Date: May 19, 2026  
To: All Prospective Bidders  
From: Sam Li  
Director of Procurement Services  
Re: Addendum Number 2  
IFB # C1746 – The Museum at FIT History Gallery Renovation

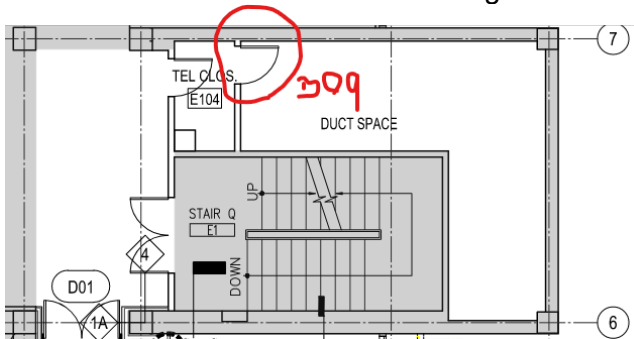
Q12. Do we need to provide the specific Guard for construction hours as mentioned in the drawings D-001?

A12. FIT will provide the guard.
